Origination Form
Proposed Revisions to a Standard Plans Index

Originator:	Frimmel, James	Index Number:	700-102
Date:	5/12/26	Sheet Number(s):	All
E-mail:	james.frimmel@dot.state.fl.us	Index Title:	Special Sign Details

ALL Sheets: Renumbered; Updating Index to accommodate changes to the Sign Library and revising dimensions for clarity.

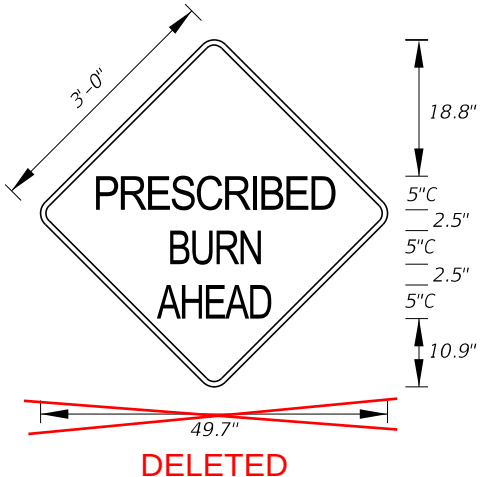
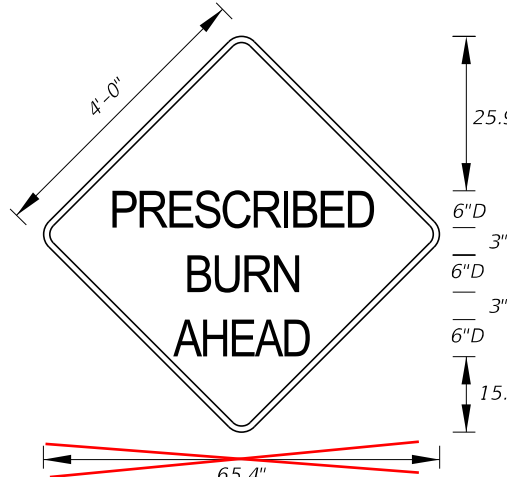
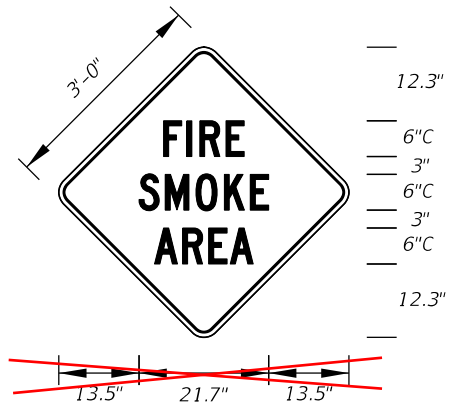
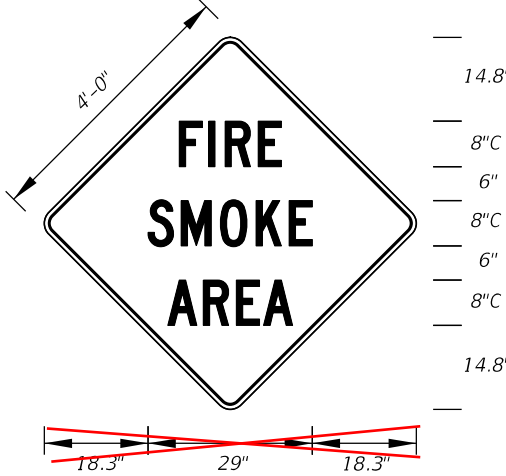
Sheet 2: FTP-007A-25 Remove 6" Series C Legend
